M5 Junction 10 Improvements Scheme

DCO Change Application 2
Flood Risk Assessment Addendum
TR010063 – APP 10.25

Change Application 2 Flood Risk Assessment Addendum

Regulation Number:	n/a
Planning Inspectorate Scheme Reference	TR010063
Application Document Reference	TR010063/APP/10.25
Author:	M5 Junction 10 Improvements Scheme Project Team

Figure 5-1 Flood depth differences for the 1% AEP plus 53% climate change allowance event

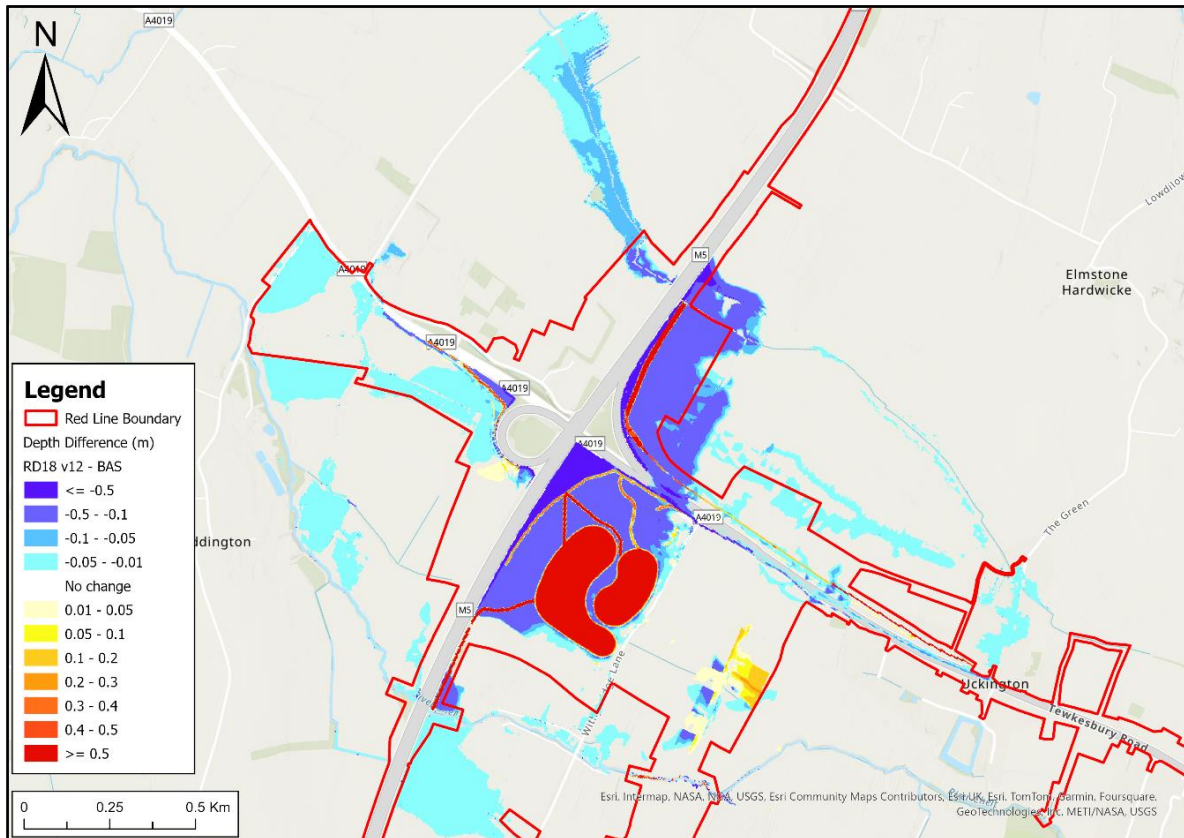
5.3.2. Figure 5-1 shows changes in flood depths between the baseline scenario and the Scheme with proposed design changes for the design event. There are large increases in flood depths in the flood storage basins in the range 1.00 m to 2.50 m, which is to be expected due to reductions in ground level. Flood depths also increase by up to 0.50 m in the new drainage ditches proposed in Change 6 for the same reason. All of these patterns are to be expected and there are no increases in flood depth outside the site boundary.

5.3.3. Figure 5-1 shows that there are reductions in flood depths along the River Chelt and the Leigh Brook, and around the Staverton Stream confluence with the Chelt.

Figure 5-3 Flood depth differences for the 1% AEP event

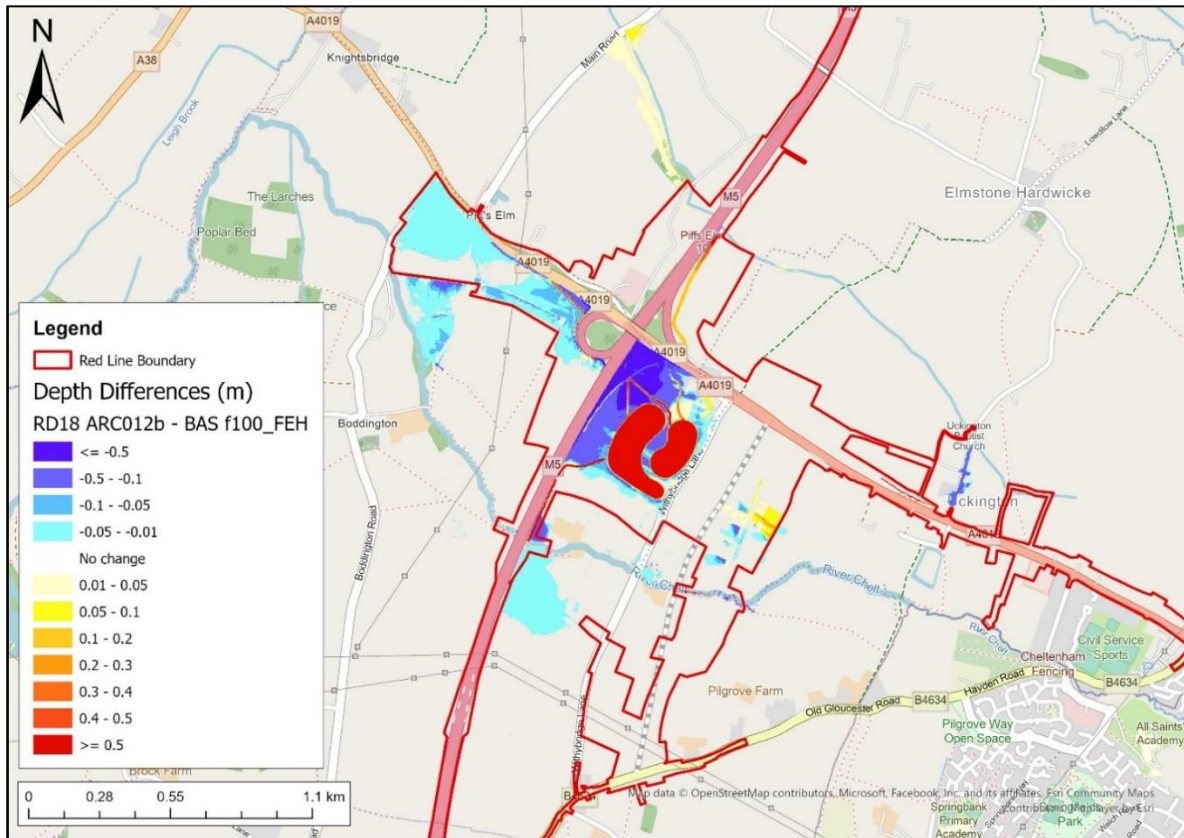
5.3.9. Figure 5-3 shows changes in flood depths between the baseline and Scheme with design change scenarios. The results are broadly similar to those shown in Figure 5-1 for the 1% AEP event plus 53% climate change allowance event. The main differences are increases in flood depths across the floodplain of the Leigh Brook downstream of the M5. These are generally less than 0.05m with isolated topographic low spots having flood depths just over 0.05m. Average depths in this area are well below 0.05m. An assessment of the impact this increase would have on overall flood risk is presented in Chapter 5.4.

5.3.10. These increases are associated with the interactions between the overflow channel conveying flow from the smaller basin and the surface water drainage system to the North of the A4019. These will be mitigated during the design development of the FSA reconfiguration which will consider these interactions in more detail.
